Change Order, Construction Manager as Adviser Edition

PROJECT: (name and address)
Central Hardin High School Addn/Renov

Change Order Number: 103

Cost associated with adding Phase II spray foam to kitchen/loading dock area per COP #54.

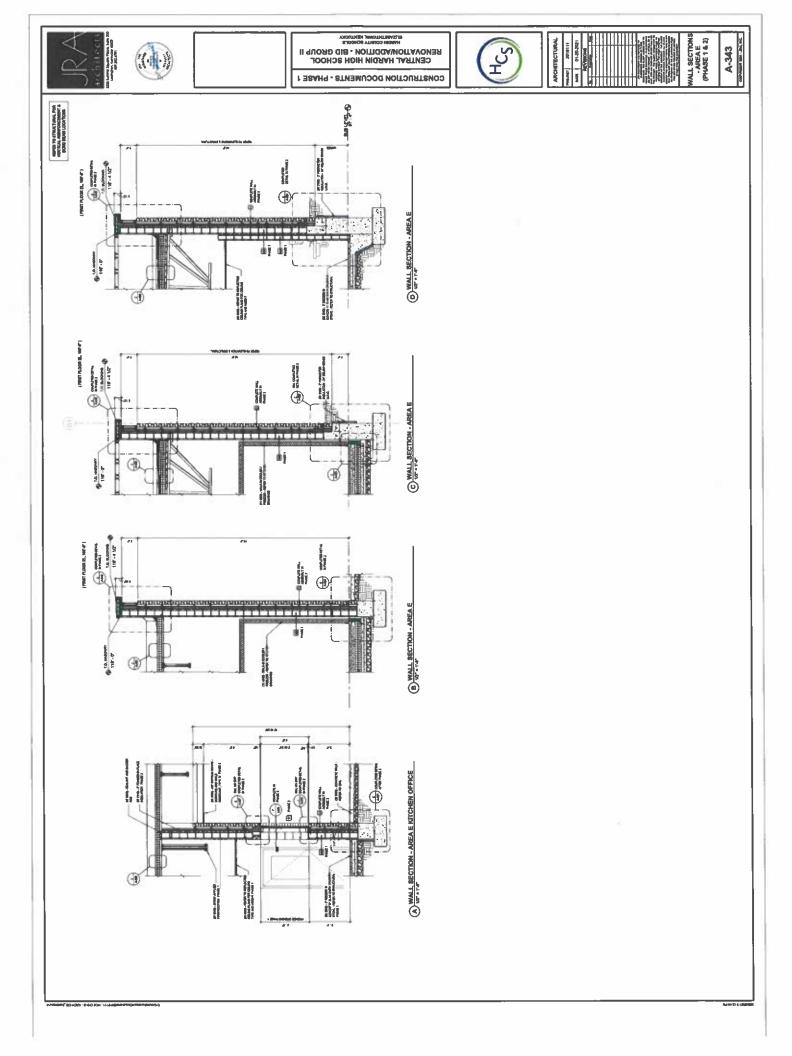
The Area E exterior CMU walls that will be exposed at the end of Phase 1 are to be sprayed with foam insulation. As shown on the wall sections on the Phase 1 drawing A-343, the exterior walls at Vocal Classroom E106, Custodial Receiving E105 and the Kitchen on the First Level will be covered with brick, metal panels, and a CMU wall in Phase 2. A portion of wall that will be an interior wall at the north entry vestibule on the First Level in Phase 2 also needs to be covered with spray foam insulation in Phase 1. That vestibule wall and the spray foam insulation will be covered with another CMU wall in Phase 2.

Break out the cost to cover the spray foam insulation with a fire and weather resistant coating. Submit product information on the proposed coating.
